July 9, 2013

Honorable David Strickland, Administrator National Highway Traffic Safety Administration 1200 New Jersey Avenue, SE Washington, D.C. 20590

Thank you for meeting with us on July 1, 2013 regarding the investigation into the 1993-1998 Jeep Grand Cherokee, 1993-2001 Jeep Cherokee and 2002-2007 Jeep Liberty for serious defects in the fuel systems and Chrysler's voluntary recall of the 1993-1998 Jeep Grand Cherokee and 2002-2007 Jeep Liberty. The key points raised during the meeting include:

Figure 1 - ZJ Kinetic Energy Comparison

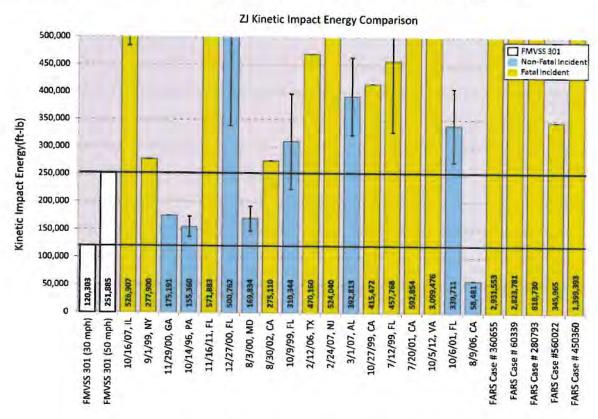
- 2) The trailer hitch may actually worsen the problem by becoming a spear to puncture the tank as happened in the death of ...
- 3) The concept of low and high energy crashes never came up in the agency's investigation. Chrysler raised the concept in its voluntary recall objection letter on June 18, 2013. Not a single one of the 44 fatal fire crashes cited by NHTSA in its June 3, 2013 recall letter is a low energy crash so the trailer hitch will not prevent a single Jeep fatal rear impact fire death. (See attached Figures 1-3 in Chrysler's June 18 letter for its analysis of high energy crashes above FMVSS 301.)
